ADDENDUM NO. 2

January 19, 2023

DUNELAND BRUMMITT ELEMENTARY SCHOOL RENOVATIONS Chesterton, IN 46304

Addendum Two (AD.02) to the drawings and specifications prepared by Gibraltar Design for **Brummitt Elementary School Renovations** for Duneland School Corporation, Chesterton, Indiana.

**FIRST FLOOR LIFE SAFETY
PLAN**

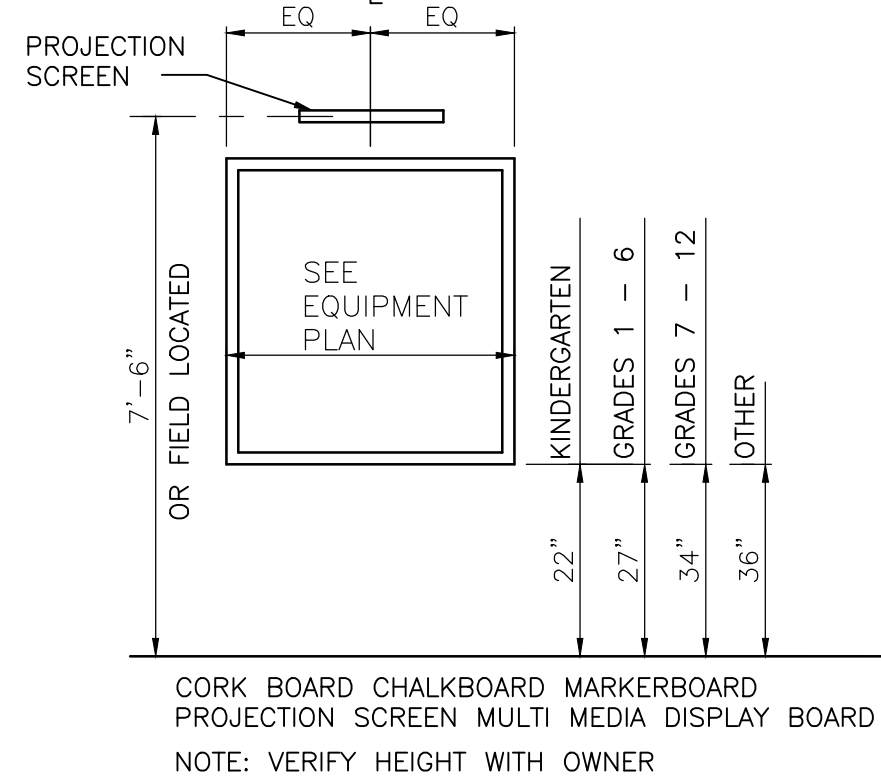
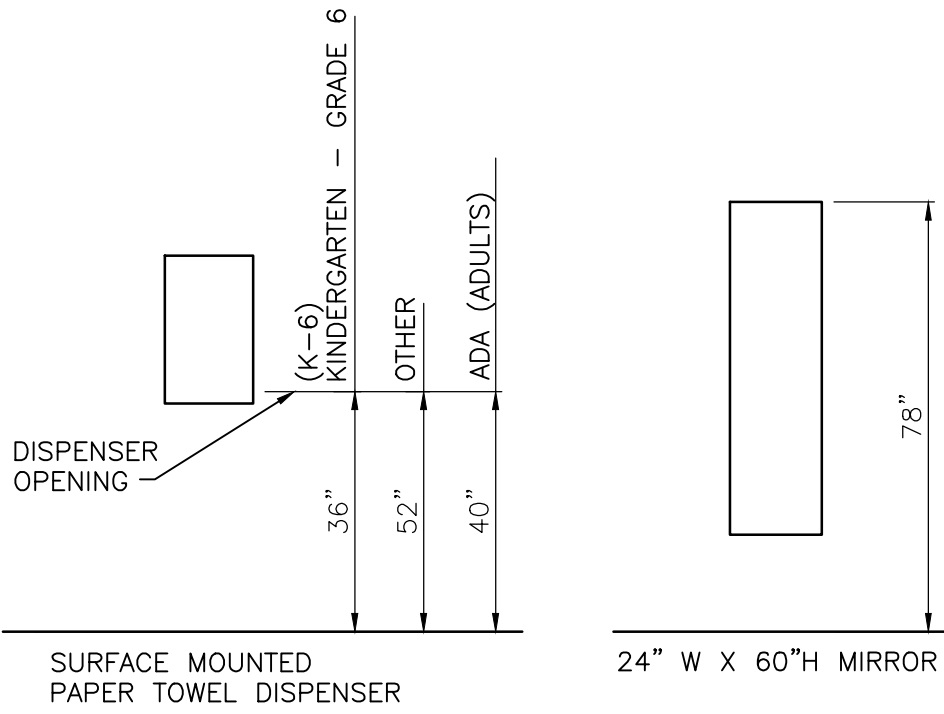
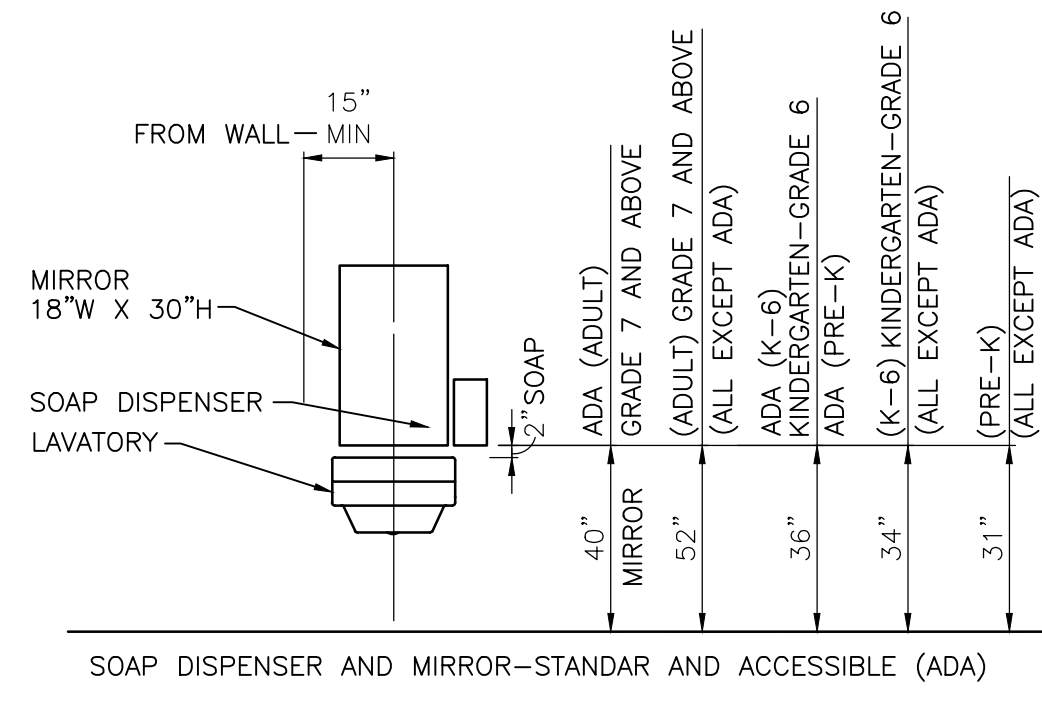
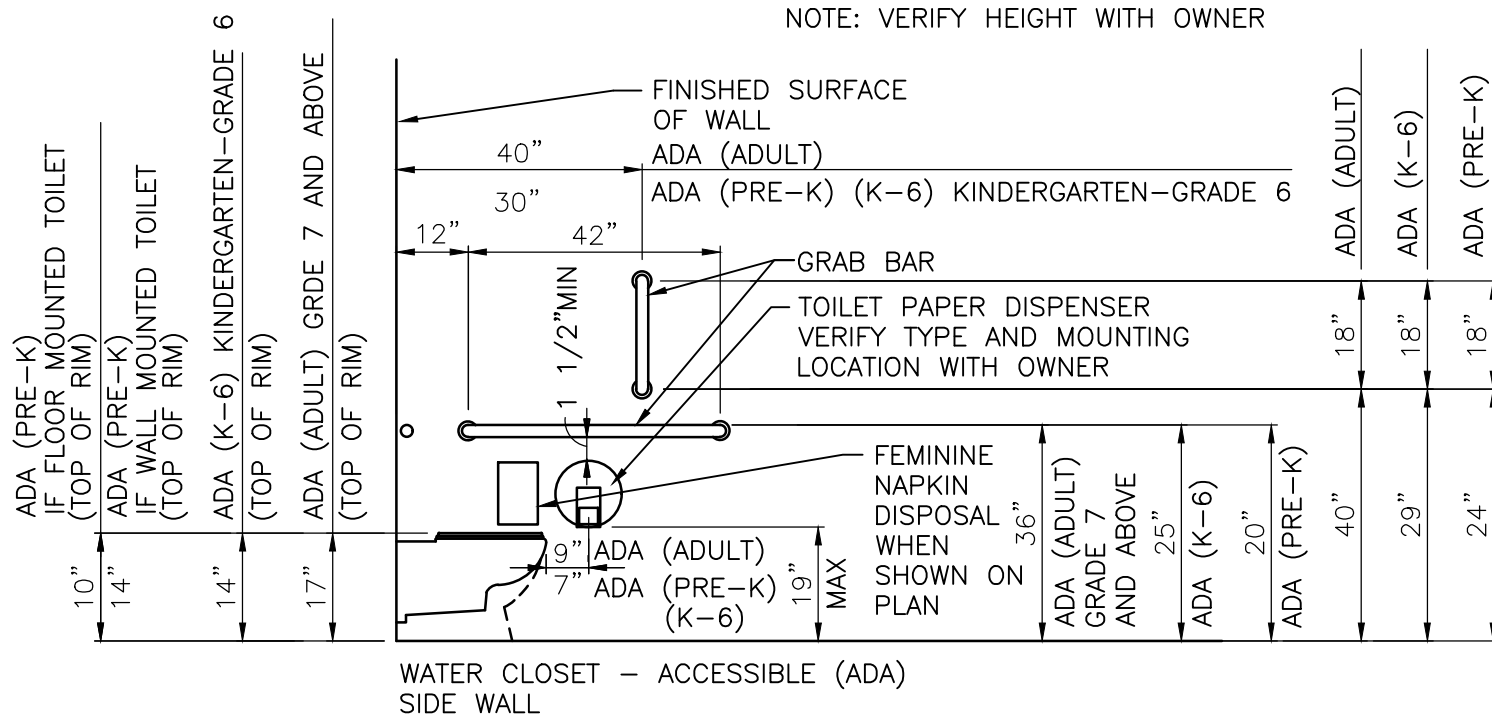
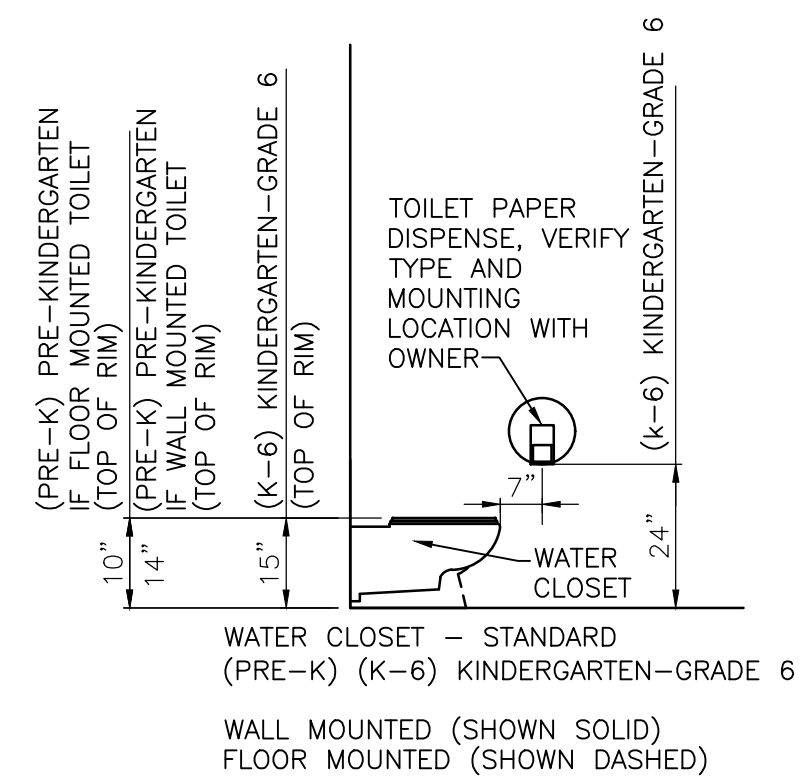
- A. Refer to revised full size drawing, included in this Addendum, for the following revisions:
 - 1. Clarify Building Door Number to differentiate between vinyl numbers on the door and number plates adjacent to the door.

G-301

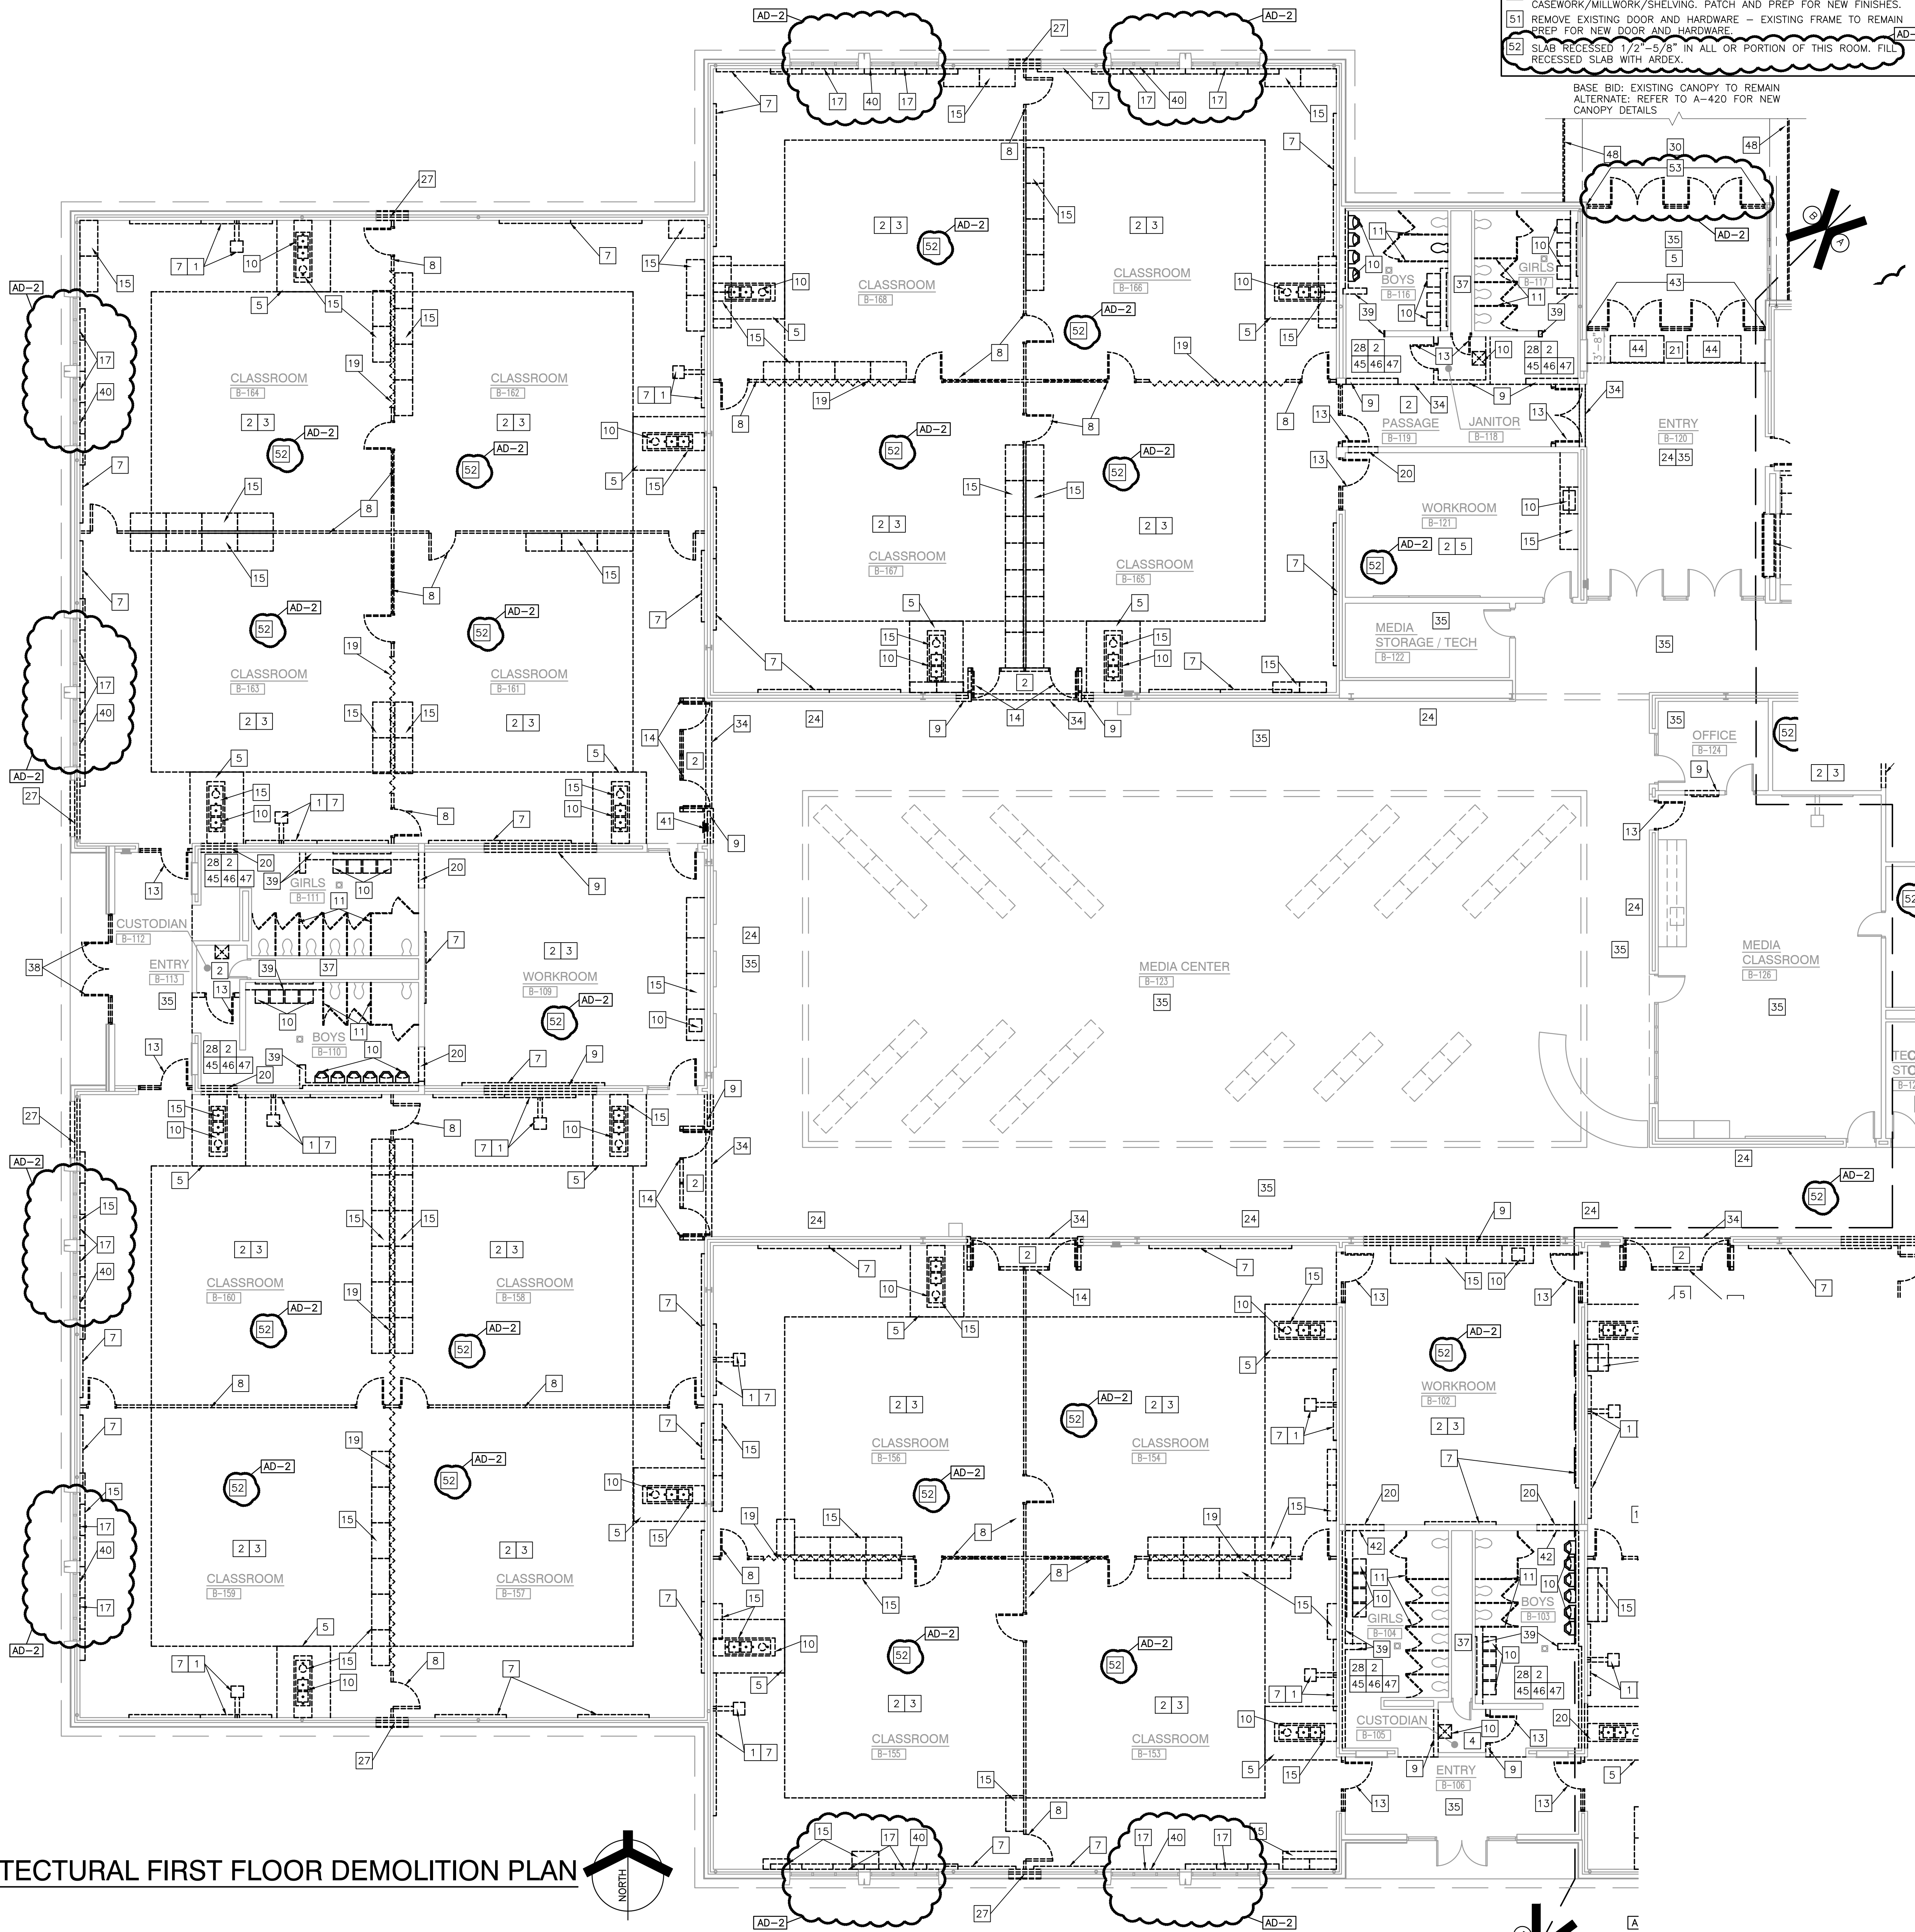
- A. Refer to revised full size drawing, included in this Addendum, for the following revisions:
 - 1. Wall Partition Types 1/G-301: Add partition type A2 and clarify height of studs required.

DRAWING
UNIT "A" ARCHITECTURAL
FIRST FLOOR PLAN

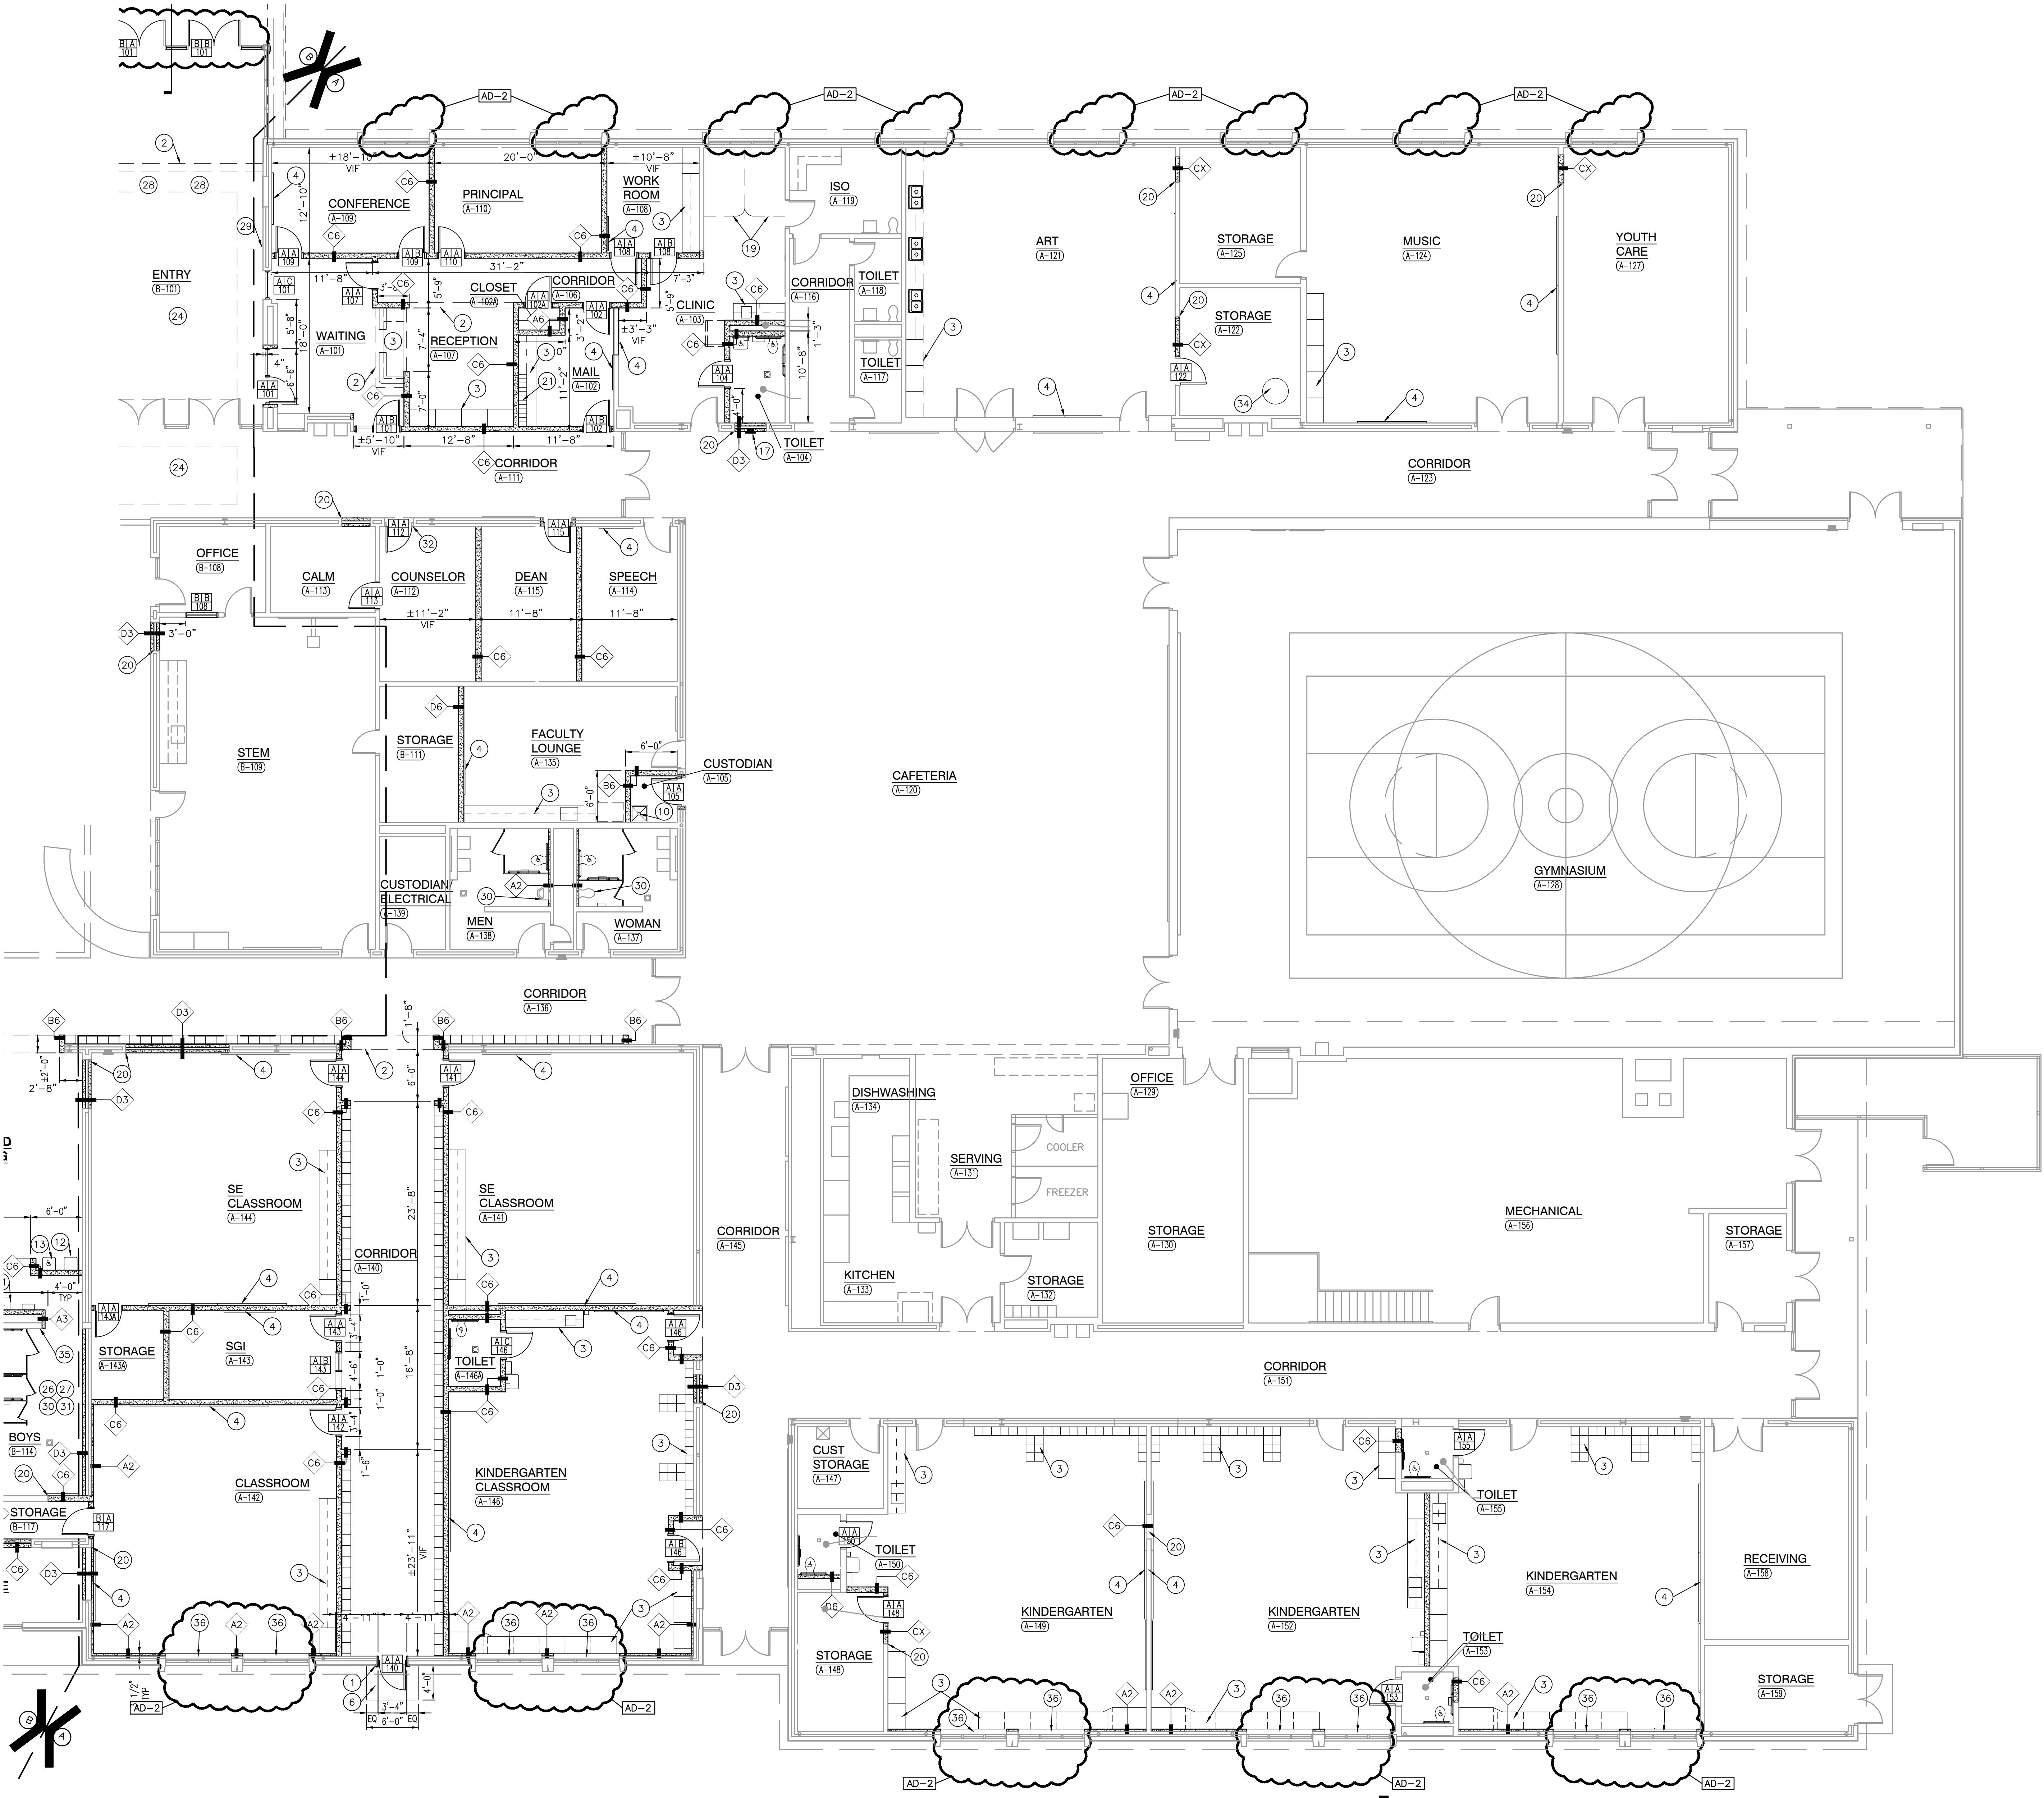
- A. Refer to two (2) revised full size drawings, included in this Addendum, for the following revisions:
1. Change new exterior windows to existing to remain and remove all W1 tags.
 2. Add Note 36 to Plan Notes with reference to 7/A-610.
 3. Add Note 36 to existing windows in rooms to receive furring on the exterior wall.
 4. Change exterior main entry storefront to new and add door numbers B-101A and B-101B.
